Stakeholder Group comments

This paper has been compiled in response to a Technical Paper by Arup Professional Services commissioned by Surrey County Council to look at safety issues in Section 1 of the Active Travel Scheme for London Road in Guildford specifically related the adequacy of carriageway widths (given the existing volumes of traffic), and to shared use paths being restricted in width through limitations imposed by the availability of land within the highway boundary.

Example 2

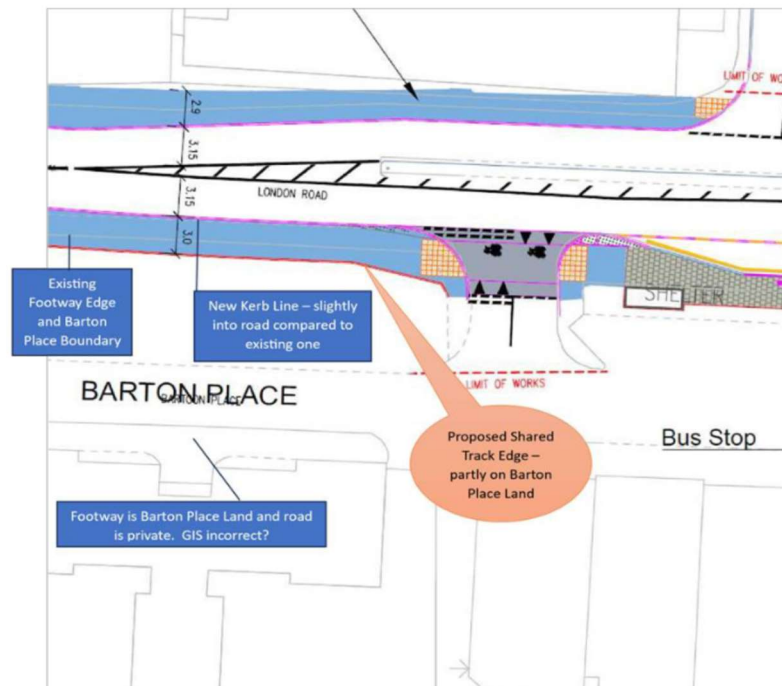
Barton Place (part of Land Registry title SY 173174) appears already to have been subsumed to create a shared path, though latest check of Land Registry shows no transfer of title, or part thereof.
